ROLLING MEADOWS/ BULL HILL
LETTER OF INTENT
Sketch Plan

January 18, 2023 (REV1)

V_2 Letter of Intent.pdf Markup Summary

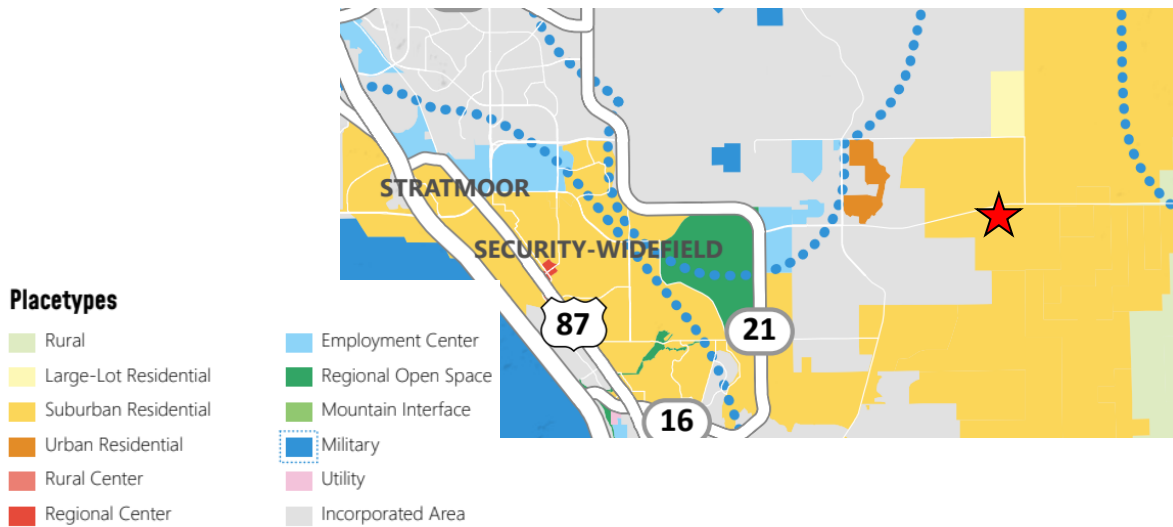
Sketch Plan Area (I added this because its still not clear that this is one sketch plan not 2- the acreages are not adding up)

Sketch Plan Area (I added this because its still not clear that this is one sketch plan not 2- the acreages are not adding up)
